Interdisciplinary Environmental Clinic

May 29, 2015

Re: Comments on Ameren Missouri's Analysis of SO₂ and Meteorological Monitoring Stations Around Its Rush Island Energy Center

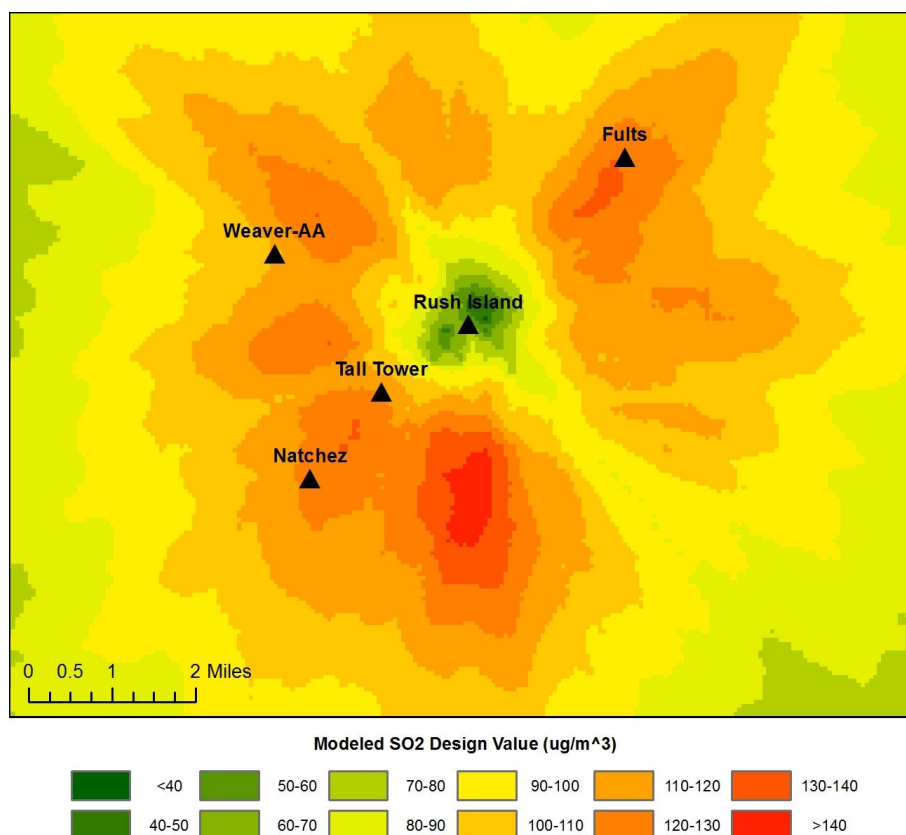
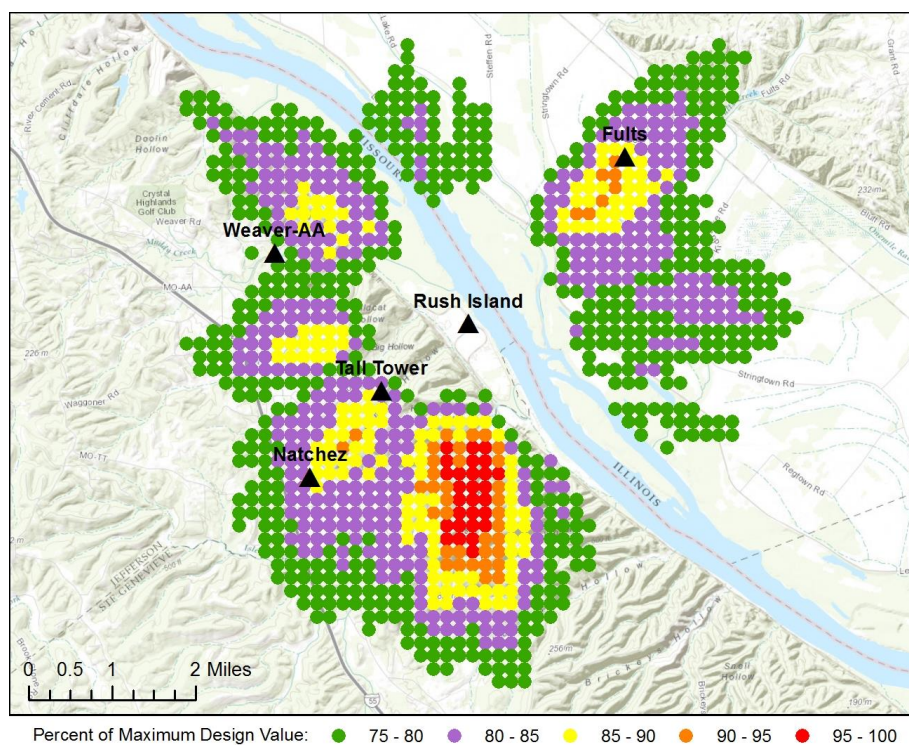
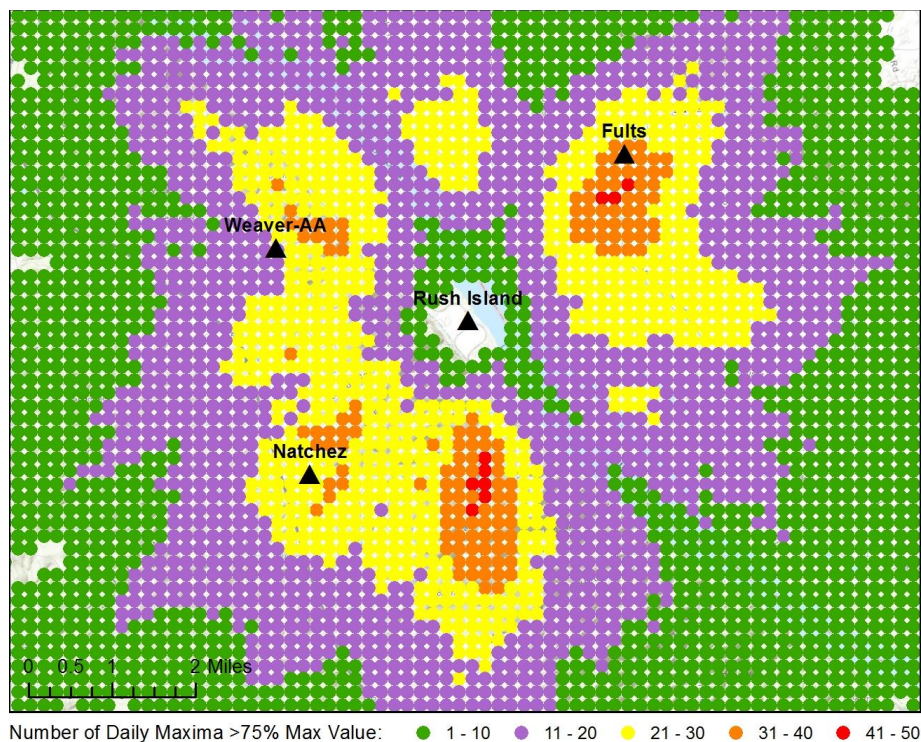
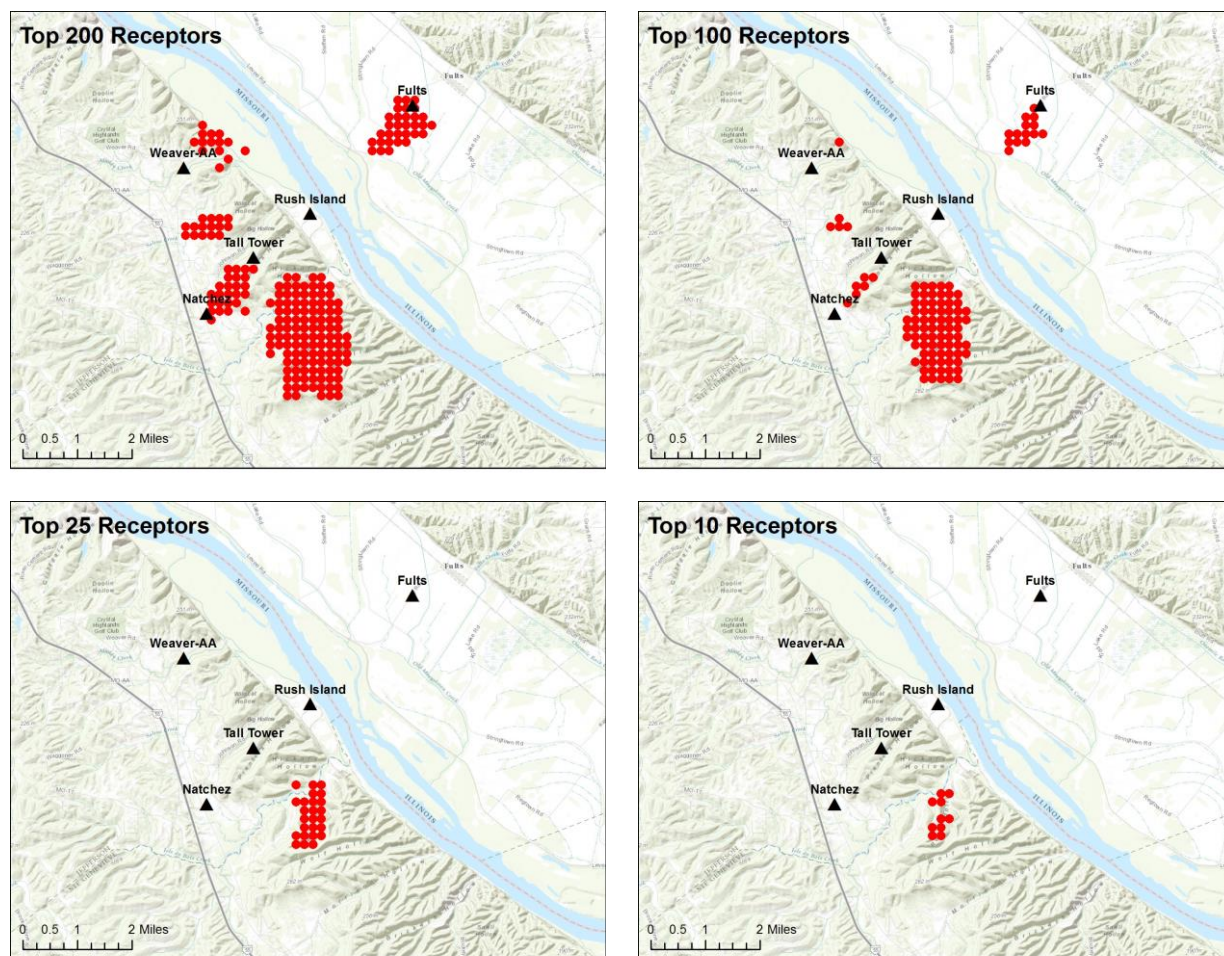
Figures 1 through 4 all reveal a strikingly similar pattern regarding the areas where peak 1-hour SO_2 concentrations are expected to occur around the Rush Island Energy Center. There is a large area due south of the plant where modeled design values are the highest (in excess of 95 percent of the maximum modeled design value), where modeled maximum daily 1-hour concentrations frequently exceeded 75 percent of the maximum modeled design value, and where over half of the top 200 receptors (including all of the top 25 and three quarters of the top 100) are located. There are also four other areas where modeled design values are slightly lower but still very high (in excess of 85 percent of the maximum modeled design value), where modeled maximum daily 1-hour concentrations frequently exceeded 75 percent of the maximum modeled design value, and where the rest of the top 200 receptors are located. These four areas, located northeast, northwest, west, and southwest of the plant, plus the area south of the plant where modeled design values are the highest, are where Ameren's modeling predicts peak 1-hour SO_2 concentrations are expected to occur. Monitoring stations located in these areas would have the greatest chance of identifying peak SO_2 concentrations in ambient air, which is the primary objective of source-oriented monitoring and an absolute necessity when monitoring to assess

compliance with the NAAQS. However, none of Ameren's proposed monitoring stations is located in any of these areas of highest expected concentrations.

The most glaring omission is that there is no proposed monitoring station in the large area of highest expected concentrations south of the plant. This omission renders the proposed monitoring network inadequate for its intended purpose of assessing compliance with the NAAQS because a) NAAQS violations are most likely to occur in this area, and b) violations could occur in this area even when concentrations are below the NAAQS in other high concentration areas, given that the modeling predicts lower SO₂ concentrations in those areas. Ameren's Monitoring Stations Analysis claims that this area is "not accessible" because it hosts an industrial plant (Holcim). The Analysis does not indicate whether Ameren sought Holcim's permission to site a monitor on the Holcim property, and does not delineate the Holcim property boundary in terms of the modeling results. In other words, it does not document the claim that this large area of maximum expected concentrations is inaccessible for monitoring. Nor does it evaluate the nearest non-Holcim site that might be available.

While we understand that the Consent Agreement between DNR and Ameren calls for monitoring, it requires that such monitoring "represents ambient air quality in areas of maximum SO₂ impact from the Rush Island Energy Center." If no monitoring site is in fact accessible in this large area of the very highest expected concentrations, then the proposed monitoring network will not fulfill Ameren's obligation under the Consent Agreement. Instead, DNR should employ modeling, which provides 360-degree coverage and can predict concentrations at otherwise-inaccessible locations, to ensure that SO₂ emissions from the Rush Island plant do not cause or contribute to NAAQS exceedances either inside or outside of the Jefferson County nonattainment area.

Figure 5. Modeled design values, receptors with design values ≥ 75 percent of the maximum modeled design value, and proposed monitoring station locations.

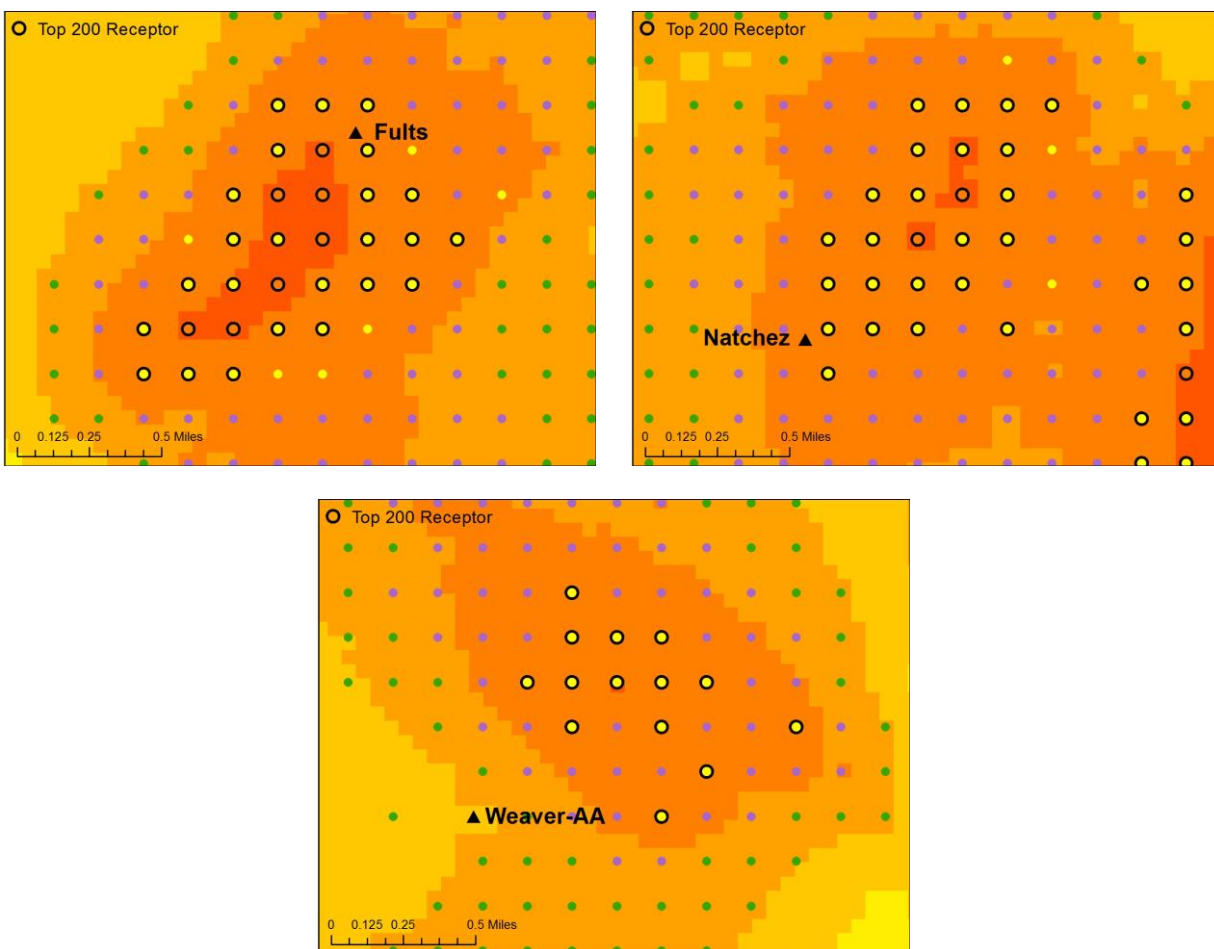
Furthermore, two of the proposed monitoring stations – Fults and Natchez – are located near but outside of areas of modeled peak concentration/high frequency instead of near the center of such areas, where concentrations are expected to be higher. The third proposed station – Weaver-AA – is located entirely outside of modeled peak concentration/high frequency areas. Figure 5 shows the locations of the proposed monitoring stations on a hybrid basemap comprised of Figures 1 (modeled design values) and 2 (receptors with modeled design values ≥ 75 percent of the maximum design value). Receptors that are among the 200 with the highest modeled design values are outlined for reference. All three monitoring stations could easily be sited in areas where higher 1-hour SO₂ concentrations are expected to occur with greater frequency, thereby increasing their chances of detecting any NAAQS exceedances that might occur around the Rush Island Energy Center. As discussed below, we urge DNR to consider these proposed optimized locations in lieu of Ameren's proposed Fults, Natchez, and Weaver-AA locations.

Fults – Of the three proposed monitoring stations, the Fults monitoring station is closest to an area where peak 1-hour SO₂ concentrations are expected to occur. However, moving the monitor less than one kilometer southwest of its current location would move it from an area with modeled design values in the 120-130 ug/m³ range to an area with modeled design values in the 130-140 ug/m³ range and place it near the center of a small group of receptors with modeled design values equal to 90-95 percent of the maximum modeled design value (the receptors

surrounding its current location generally have modeled design values equal to 85-90 percent of the maximum modeled design value). The entire area is floodplain/agricultural and Ivy Road, oriented northeast-southwest, runs through the middle of it, making the proposed optimized location as accessible as Ameren's proposed location and equally easy to provide power to.

We urge DNR to reject the proposed monitoring sites and require Ameren to add a monitoring station in the highest concentration area due south of the plant as well as to relocate the proposed Fults, Natchez, and Weaver-AA monitoring stations to the optimized locations shown in Figure 5. We also urge DNR to require Ameren to 1) rerun the air dispersion model described in the report using Rush Island's actual hourly emissions; 2) evaluate the effects of nearby interactive sources (including, at a minimum, River Cement, St. Gobain Containers, Holcim, Mississippi Lime, Dynegy's Baldwin Energy Complex, and Ameren's Meramec Energy Center) on modeled peak concentration/high frequency areas; and 3) evaluate the appropriateness of using meteorological data from the Cahokia, Illinois airport instead of Doe Run Herculanum given DNR's determination that the latter is more representative of the modeled area.⁷ We further urge DNR to require any necessary adjustments to the proposed monitoring network based on the results of these analyses.

Figure 6. Current and optimized locations of the Fults, Natchez, and Weaver-AA monitoring stations

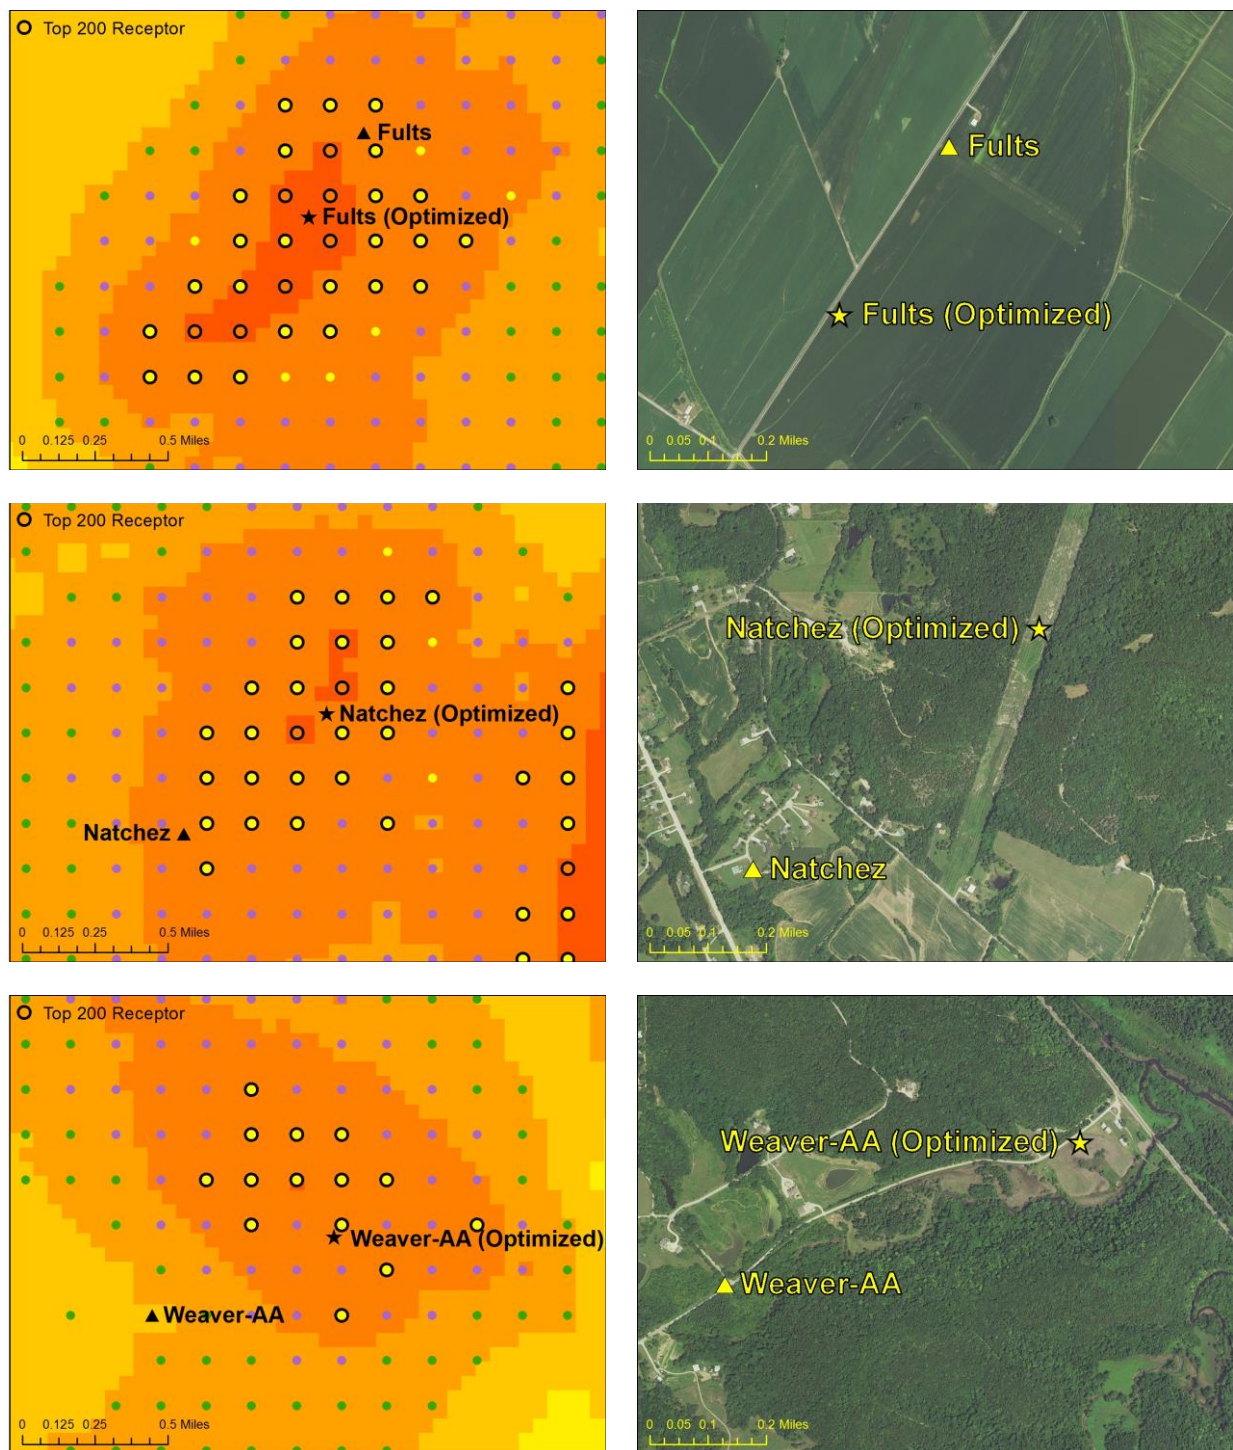
Natchez – The Natchez monitoring station is outside/on the outer edge of an area where peak 1-hour SO_2 concentrations are expected to occur. Moving it approximately one kilometer northeast of its current location would move it from an area with modeled design values in the $120\text{-}130 \text{ ug/m}^3$ range to an area with modeled design values in the $130\text{-}140 \text{ ug/m}^3$ range, and place it between a pair of receptors with modeled design values equal to 90-95 percent of the maximum modeled design value (the receptors surrounding its current location have modeled design values equal to 80-90 percent of the maximum modeled design value). It would also move it to an area where higher concentrations are expected to occur with slightly greater frequency. The proposed optimized location is accessible via transmission right of way, and power is available along Dubois Creek Road to the south-southwest.

Weaver-AA – The Weaver-AA station is located completely outside of all areas where peak 1-hour SO₂ concentrations are expected to occur. Modeled design values at its location are only in the 100-110 ug/m³ range, and it is surrounded by receptors with modeled design values equal to just over 75 percent of the maximum modeled design value. Moving the monitor just over one kilometer east-northeast of its current location would place it in an area where modeled design values are 15-20 ug/m³ higher, in the midst of a slightly dispersed group of receptors with modeled design values equal to 85-90 percent of the maximum modeled design value. At this optimized location, concentrations in excess of 75 percent of the maximum modeled design value are expected to occur roughly twice as often as at Ameren's proposed Weaver-AA location. The proposed optimized location is readily accessible via State Highway AA, and power is available along the highway.

Figure 6 compares the locations of Ameren's proposed Fults, Natchez, and Weaver-AA monitoring stations with optimized locations more likely to record maximum SO₂ concentrations in the area.
